F/CMVSS Noncompliance Recall

N212340735 Tire Loading Information Incorrect

Revision: 02

Revision Description: This bulletin is being revised to update the parts language. Please discard all previous copies of N212340735.

5868279

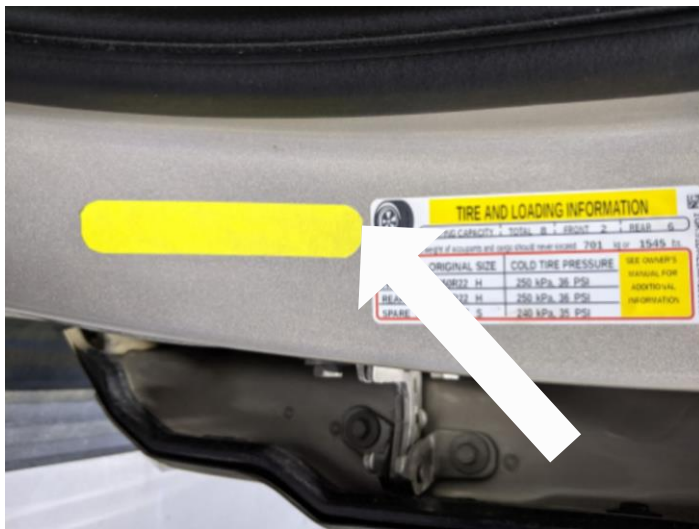
Note: The graphic below shows both the US and Canadian versions of the Cargo Carrying Capacity Label.

2. Select the appropriate language Cargo Carrying Capacity Reduced Label for your sales market.
